Airworthiness Directives; Schweizer Aircraft Corporation Model 269A, 269A-1, 269B, 269C, and TH-55A Helicopters

ACTION: Notice of proposed rulemaking (NPRM).

Schweizer Aircraft Corporation: Docket No. 2002-SW-25-AD. Revises AD 2003-13-15, Amendment 39-13217.

Figure 1

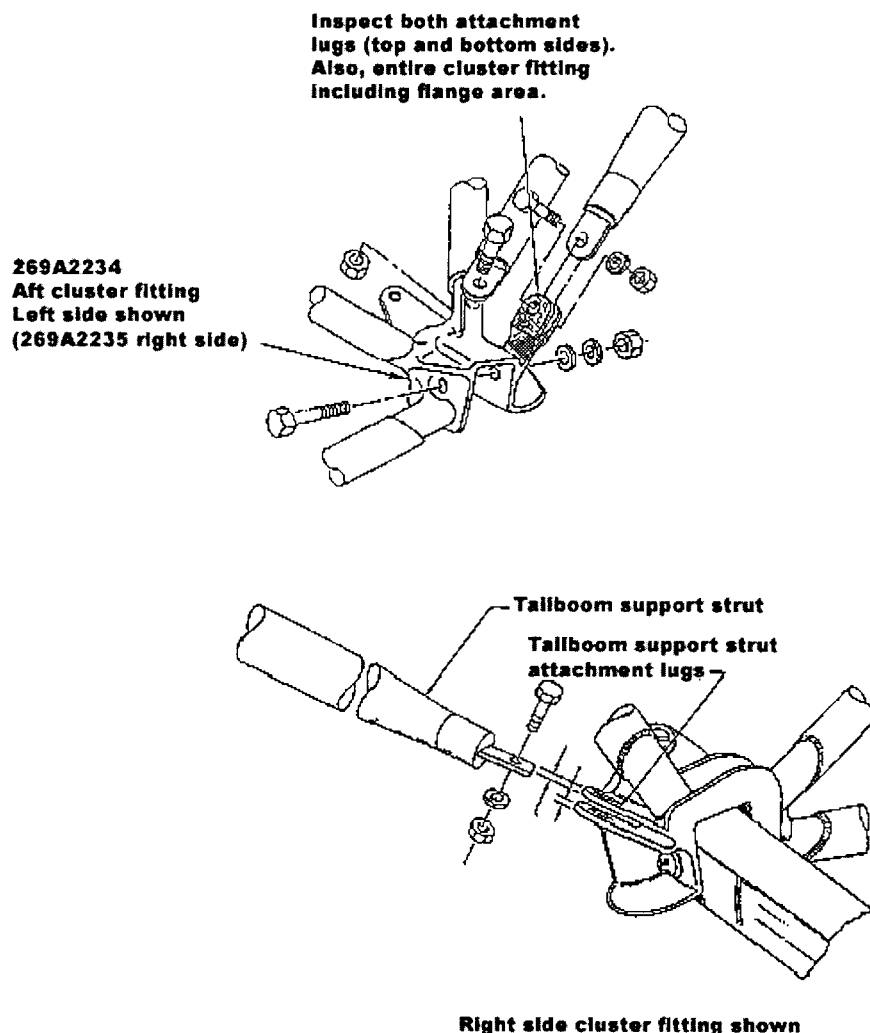
(1) Using paint remover, remove paint from the lugs on each cluster fitting. Wash with water and dry. The tailboom support strut must be removed prior to the paint stripping.

(2) Dye-penetrant inspect the lugs on each cluster fitting. See the following Figure 1:

(3) If a crack is found, before further flight, replace the cracked cluster fitting with an airworthy cluster fitting.
